## PLANNING TECHNICAL REVIEW COMMITTEE –AGENDA

Meeting Type: Regular Meeting  
Meeting Location: Council Chambers, City Hall, 288 Central Ave, Dover NH 03820  
Meeting Date: **Thursday, December 1, 2022**  
Meeting Time: **10:30 AM**

**Re: Application for Site Plan Review and Conditional Use Permits  
Durham Road, Dover  
Tax Map H, Lot 11  
Dover Project #P22-38  
P4952**

On behalf of Summit Land Development, Altus Engineering, Inc. (Altus) is pleased to re-submit the attached application material for Subdivision and Site Plan Review to construct the proposed medical office building on Durham Road, Tax map H, Lot 11. The applicant met with the Technical Review Committee (TRC) on June 2, 2022 and again on October 20, 2022 and received comments. As discussed at reviews, the applicant (McEneaney Survey Associates) has prepared a Subdivision application Subdivision Plan of Land for the property and has included it in this submittal. Below is a response to comments received from the various reviewers at the October 20, 2022 meeting.

8 (C-3)

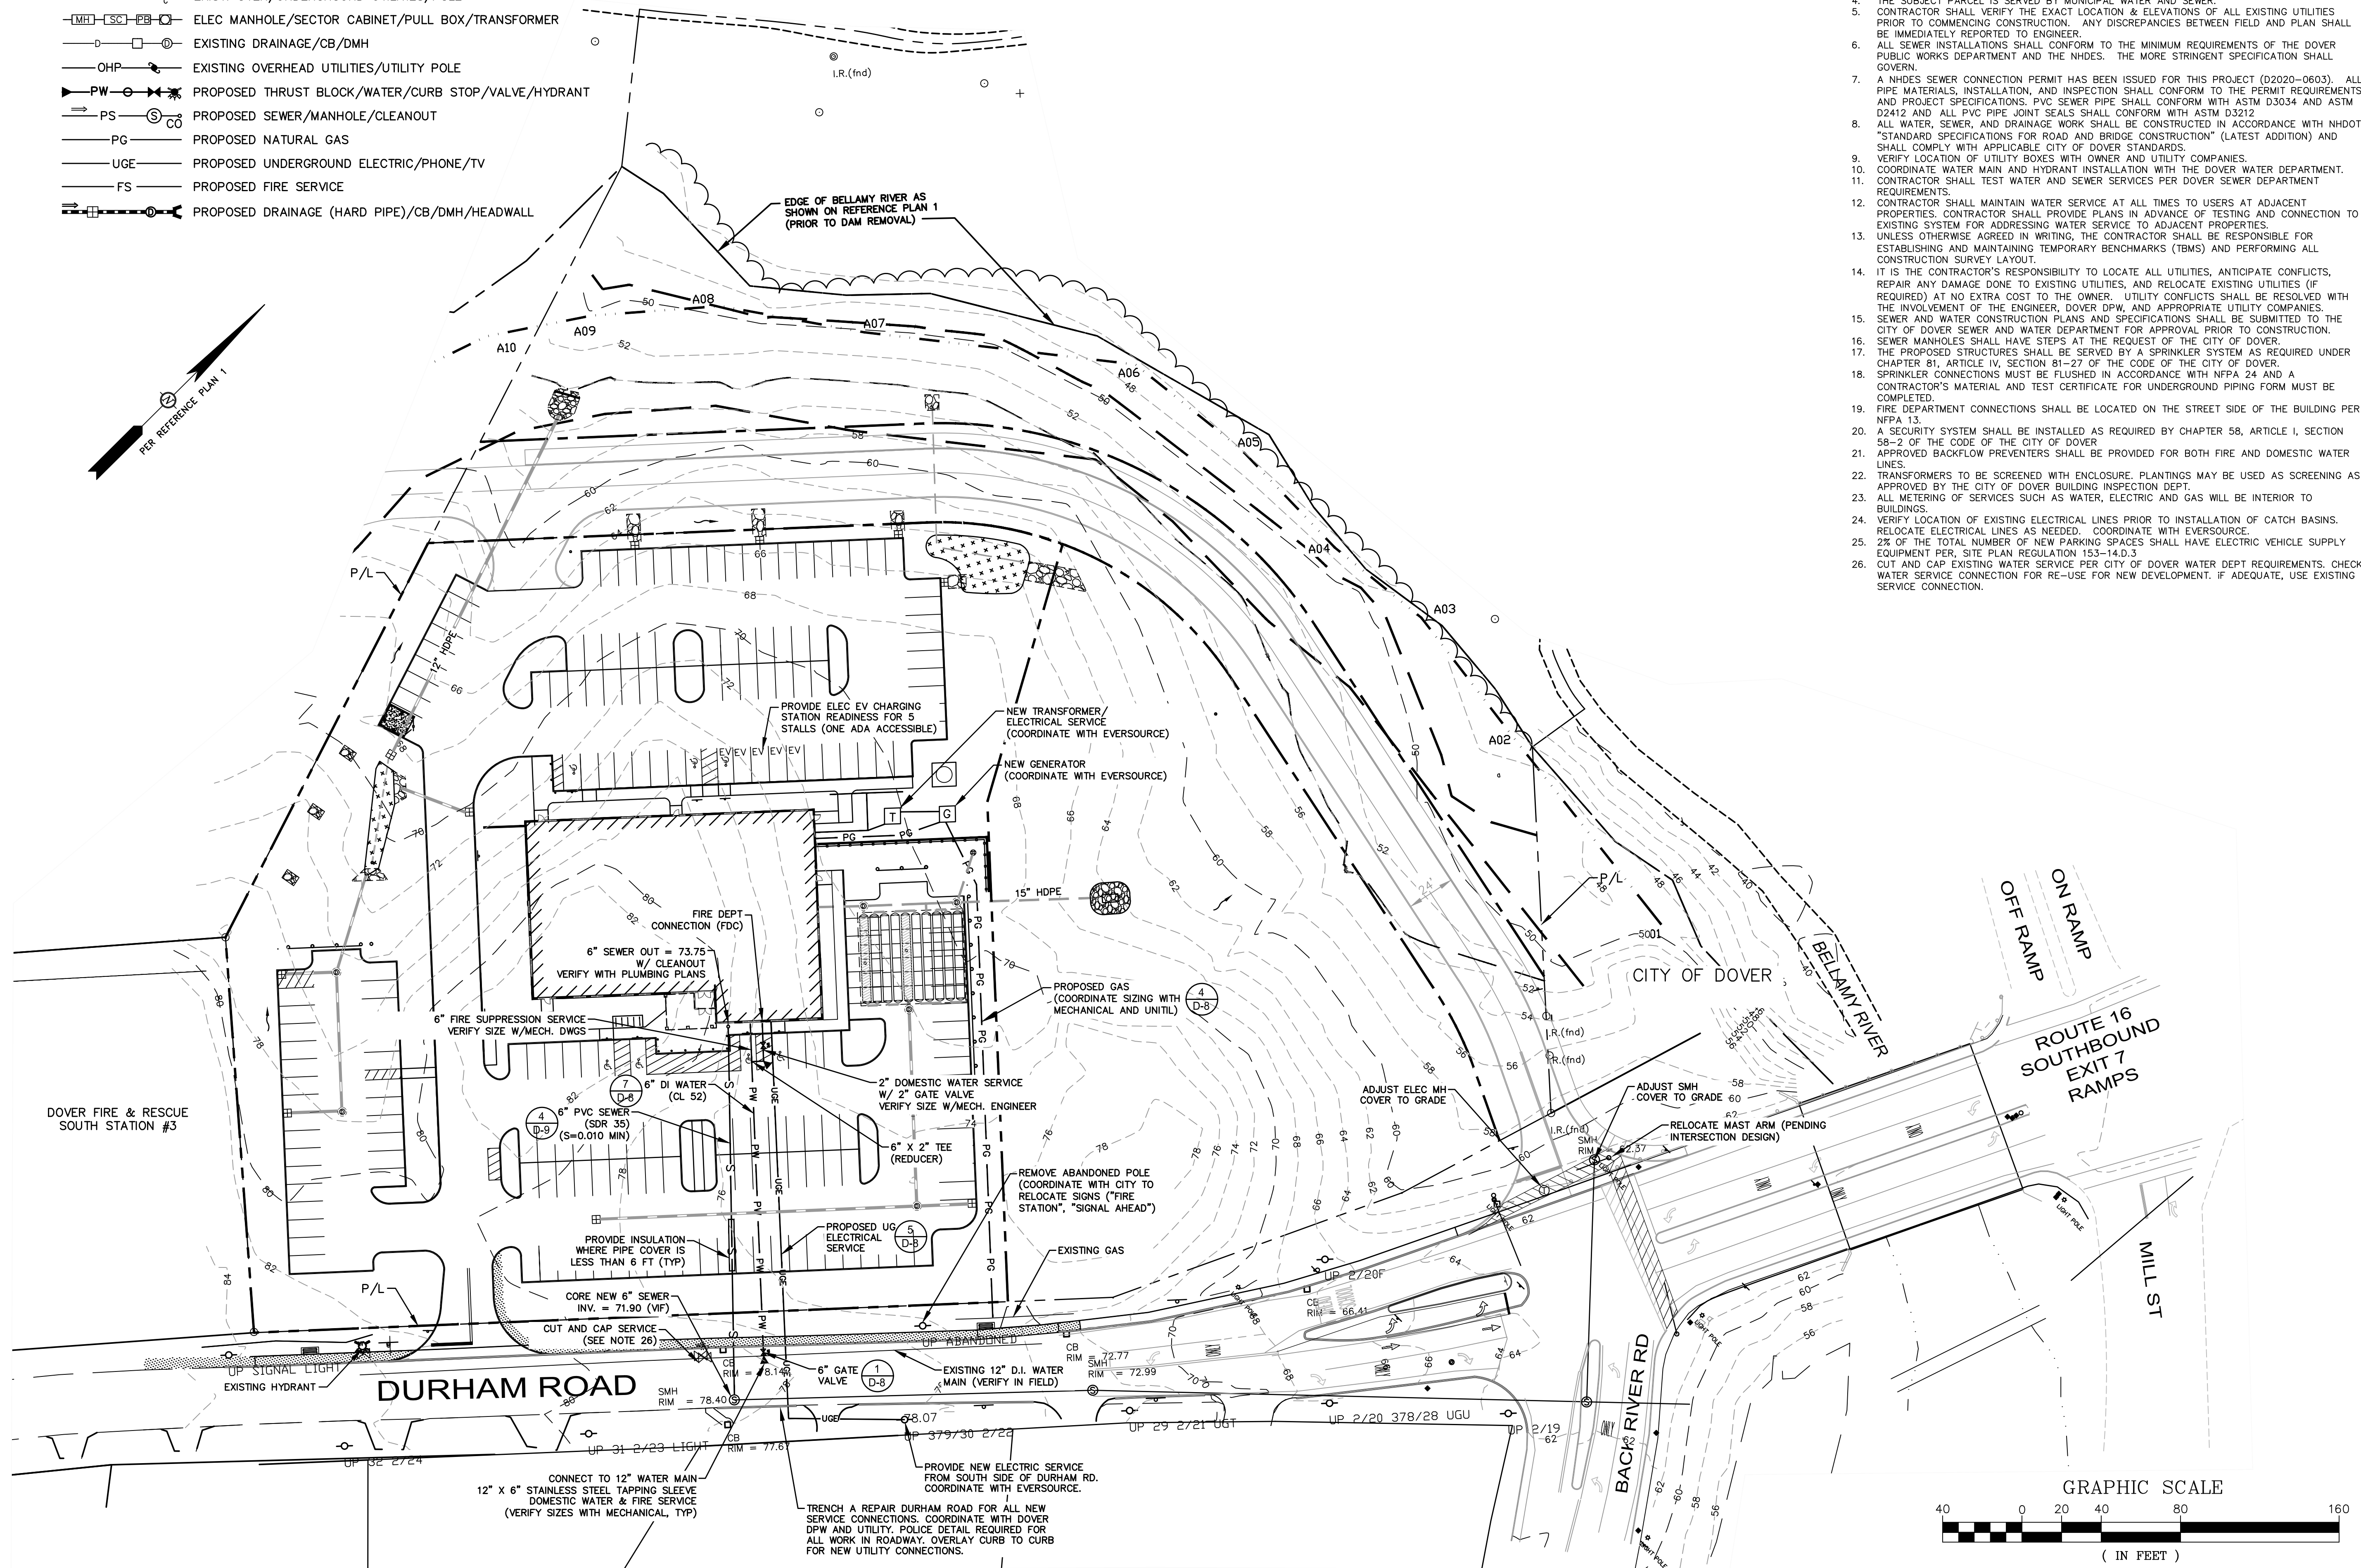
- A note is added to indicate it is to be revised during Phase 2.
- C-3:ADS Infiltration System: Please show the header rows connecting the units. Recommend adding a note that the header rows be sized per manufacturers recommendations.

- Header rows connections added and note to that pipe manifold sizes to be verified with manufacturer.
- C-3:Check the grading along the frontage of Durham Rd near the curb. It is not correct.

- The grading along the front curb line has been revised.
- C-3:Please check that there is sufficient shoulder provided wherever guardrail is called out.

- The shoulder is increased to 3 feet to allow adequate space for guardrail.
- C-3:Will drainage easements required on the phase II lot? Provide if necessary.

UTILITIES PLAN

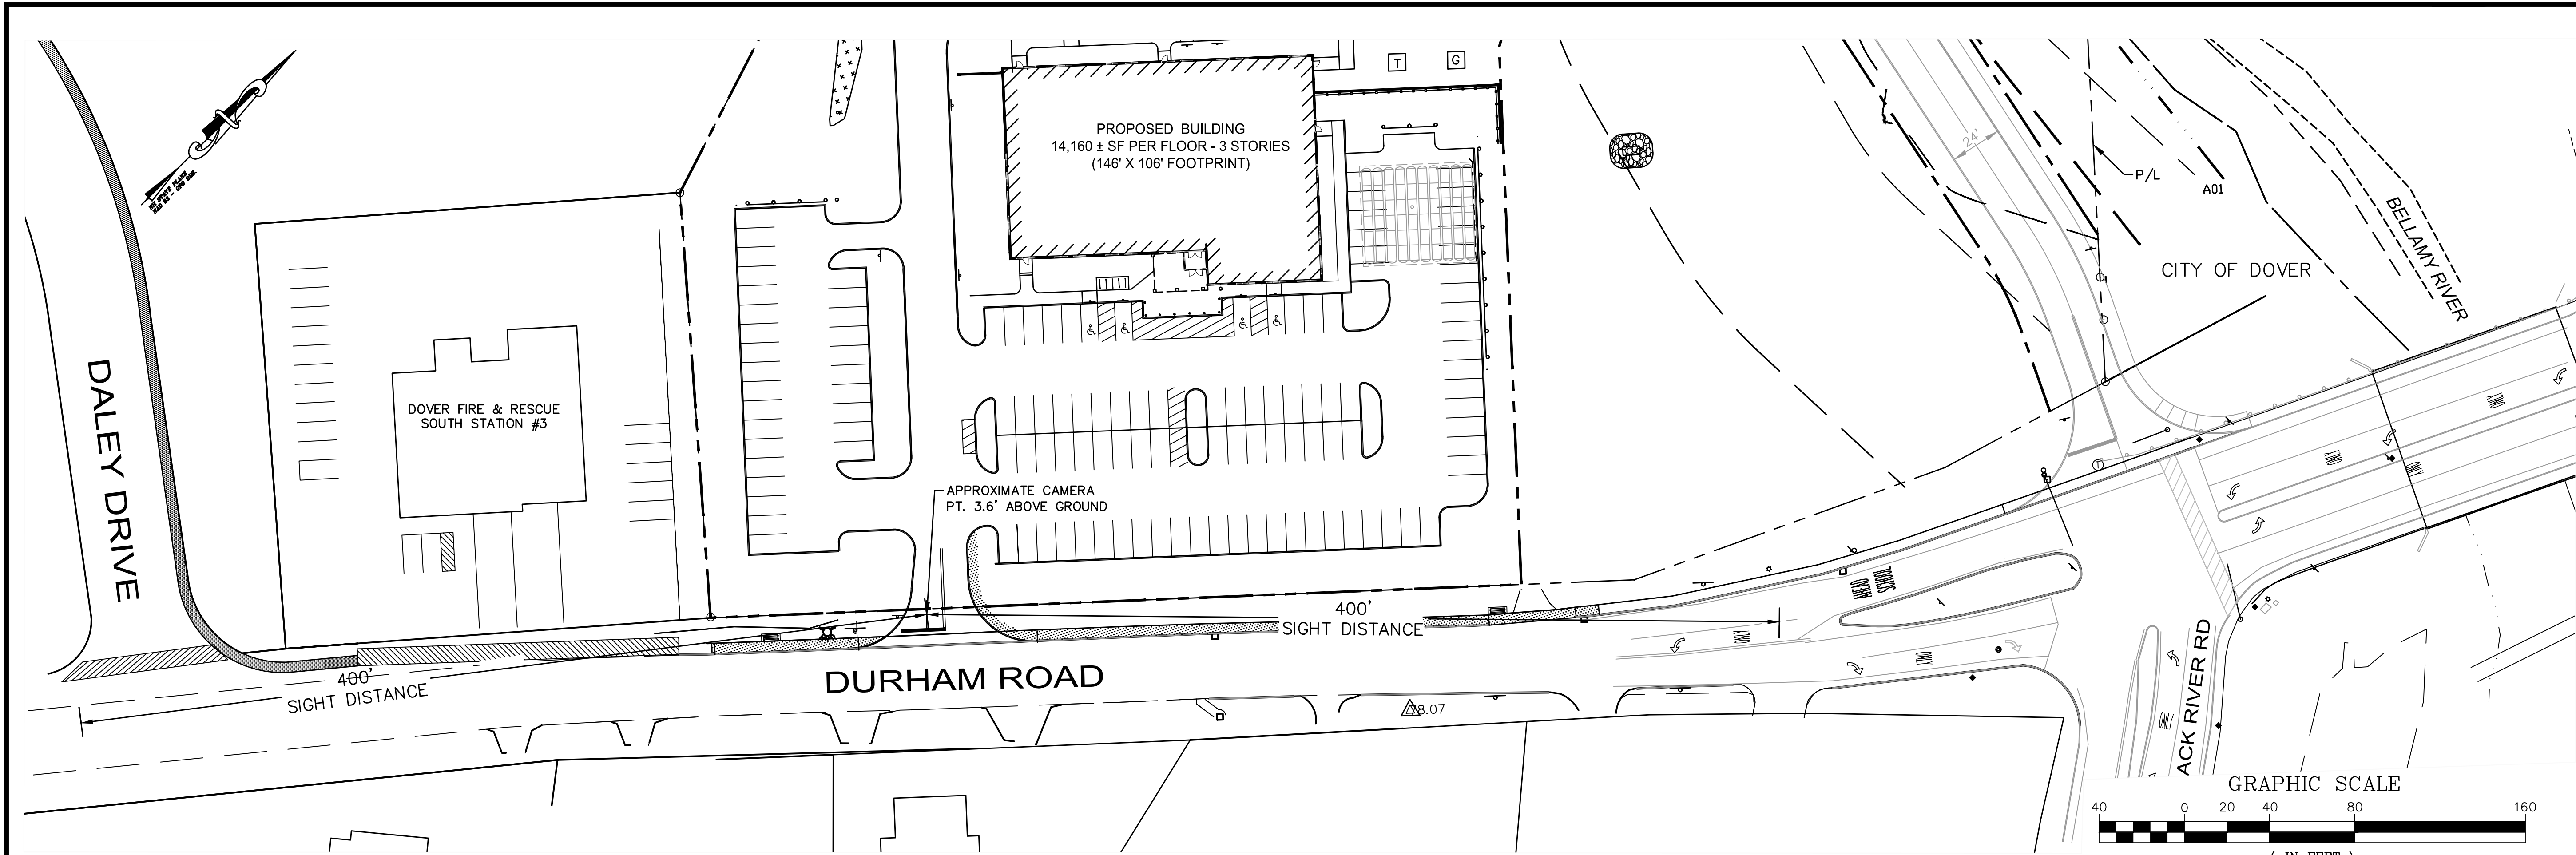
- The same owner owns both lots so the easement will be recorded if either property changes ownership. A note is added to the plans.
- C-4:Add gate valve after the domestic service branch off and reducer to change the pipe diameter.

- 6" tee and reducer added with 2" gate valve on domestic water.
- C-4:Minimum slope for 6-inch sewer service is 1%. Please revise.
  - The slope was revised to 1% minimum.

- C-4:Sewer with less than 6 feet of cover below pavement is required to have insulation.
  - Note added for insulation if cover is less than 6 feet.
- C-4:Existing water valves in Durham Rd are for existing water services at subject property. Can the development reuse these instead of connecting to the main as proposed?

- C-4:If existing water services are not used, please provide a gate valve adjacent to the tapping sleeve.
  - Gate valve added at street for new connection.

- C-4:Consolidate the utility trenches within Durham Rd and provide overlay of entire area of disturbance from curb to curb.
  - The utilities are combined to a single trench. Road to be overlaid urb to curb.

- C-4:Gas service is shown connecting to water main.
  - The gas line connection is revised
- General Comment: Please provide a number or letter for each of the details.

- The existing service was for a single family residential house. It is not anticipated that the valves will be adequate for the new development. A note is added to cap existing service, so the service can be inspected to see if it can be used for a new connection.

5 PRETEX CURB INLET PRETREATMENT DEVICE NOT TO SCALE

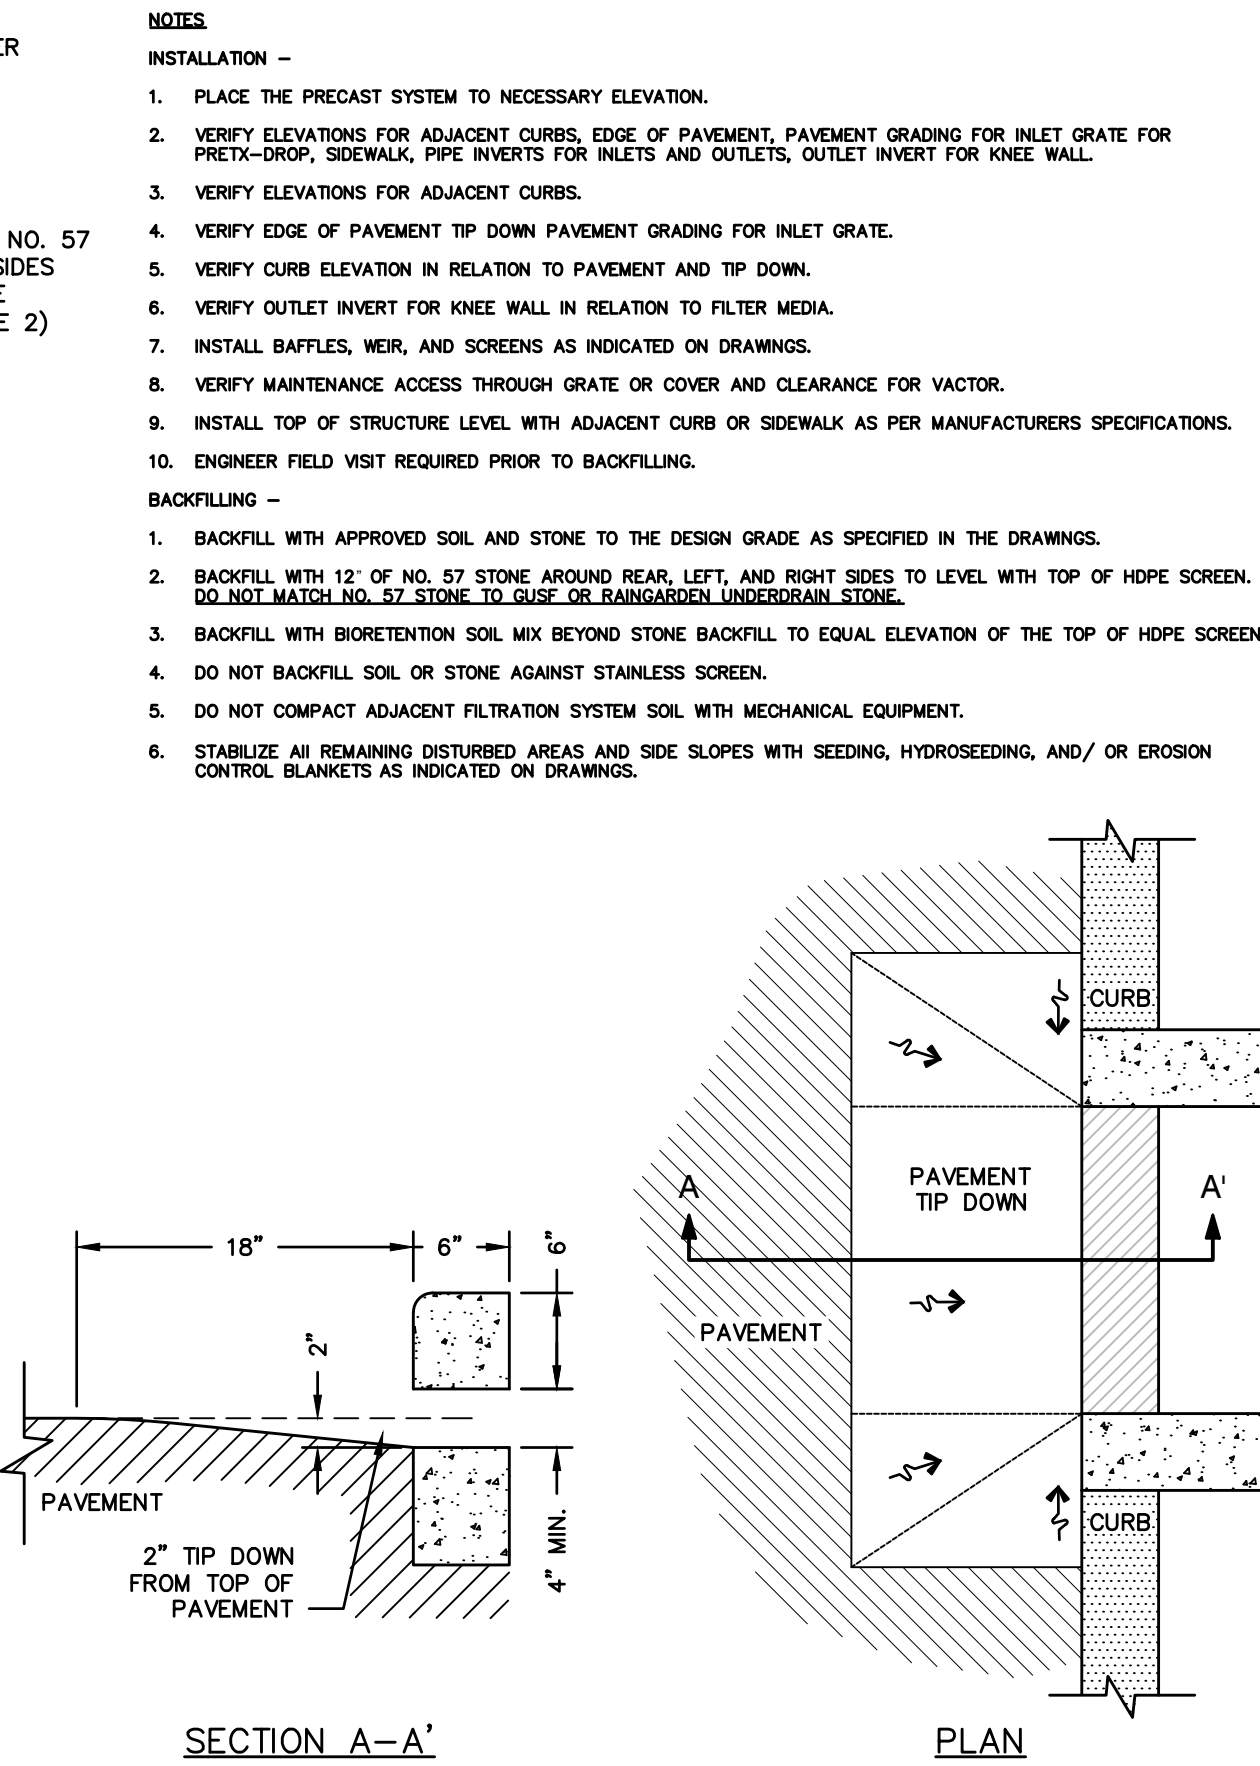
- The details have been updated with numbers and added to sheet layouts.
- D-3:Add dimensions to baffle and weir so that they can be constructed. For example: How far from bottom and top of structure? What is the material of the baffle/weir?

- The dimensions have been added. It should be noted the Pret-tex curb inlets pre-treatment devices are prefabricated units.
- D-5:Evaluate depth of wood guardrail. Depth seems insufficient for use on steep slopes.
